**Re: 14CVCP226X  
E-Des # 14EHAN171X  
1939 West Farms Road, Bronx, NY  
Remedial Action Work Plan (RAWP) Stipulation List**

Hydro Tech Environmental, Corp. of New York hereby submits a Remedial Action Work Plan (RAWP) Stipulation List for the Site to the New York City Office of Environmental Remediation (OER) on behalf of Shri Sainath, LLC. This letter serves as an addendum to the RAWP to stipulate additional content, requirements, and procedures that will be followed during the site remediation. The contents of this list are added to the RAWP and will supersede the content in the RAWP where there is a conflict in purpose or intent. The additional requirements/procedures include the following Stipulation List below:

FIGURE 2: SCHEMATIC SECTION DETAILS OF VAPOR BARRIER

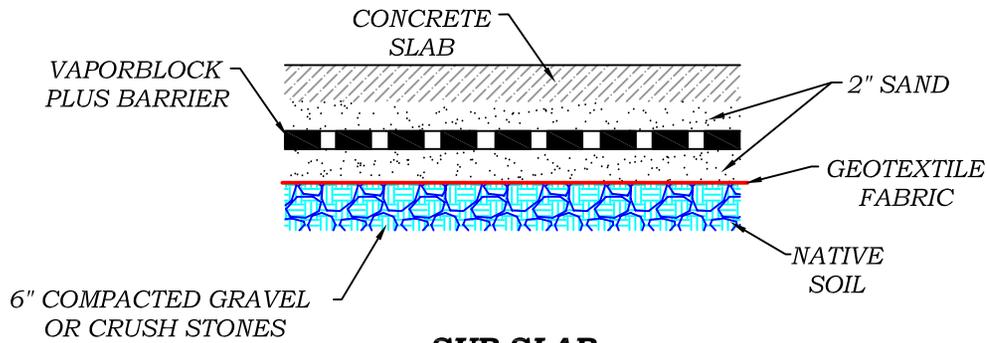
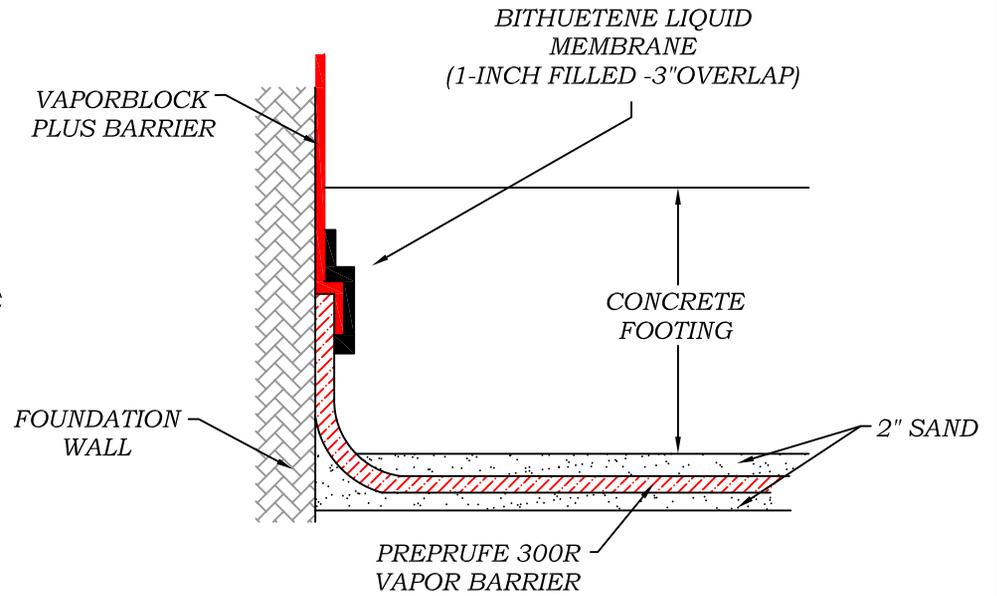
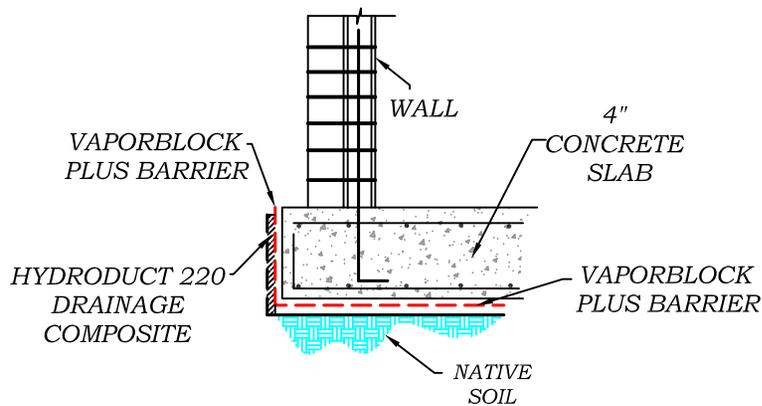
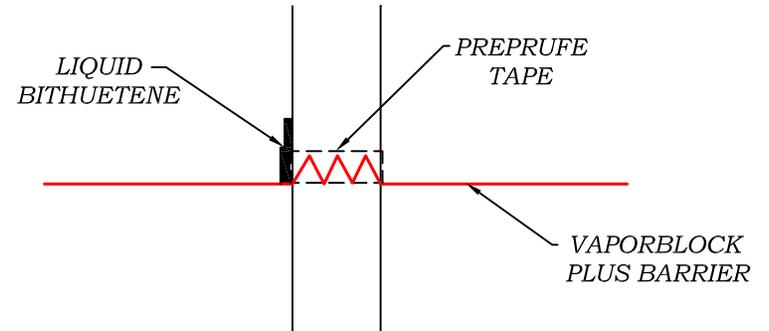
8. Daily reports will be provided during active excavation work. If no work is performed for extended time period, daily report frequency will be reduced to weekly basis. Daily report template is attached in **Appendix 5**.
9. A [20]-millimeter vapor barrier will be installed beneath the structure's slab and along foundation sidewalls. The barrier chosen for this project is manufactured by Vaporblock Plus, model number VBP20. **Appendix 6** provides manufactures specifications and PE/RA certified building plans with the extent of the vapor barrier installation details (penetrations, joints, etc.) with respect to the proposed foundation, footings, etc.
10. Truck route is included in **Appendix 7**.
11. The stamped/signed RIR and RAWP certification pages are included in **Appendix 8**.
